BLUE COLUMBINE Wheat Ridge, CO

50% SD

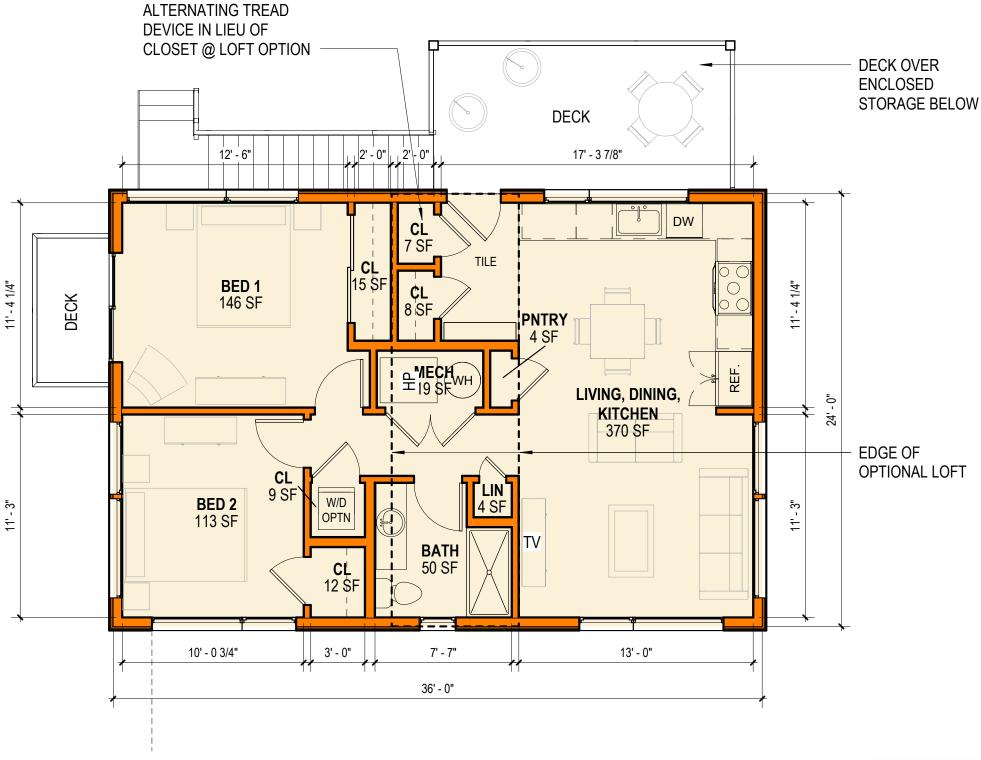
- KITCHEN FLIPPED TO ESTABLISH ENTRY CLOSER TO MIDDLE OF PLAN FOR MORE EFFICENT CIRCULATION AND TO ALLOW PRIVACY WALL OPPOSITE OF DEACK AREA OFF BR 1
- SPACE FOR HEAT PUMP ADDED AT MECH. SEPARATE OPTIONAL LAUNDRY CLOSET PROVIDED
- CLOSET AT BR 2 ADDED
- LARGER SINK AT BATH
- MORE DEFINED ENTRY
- PANTRY ADDED
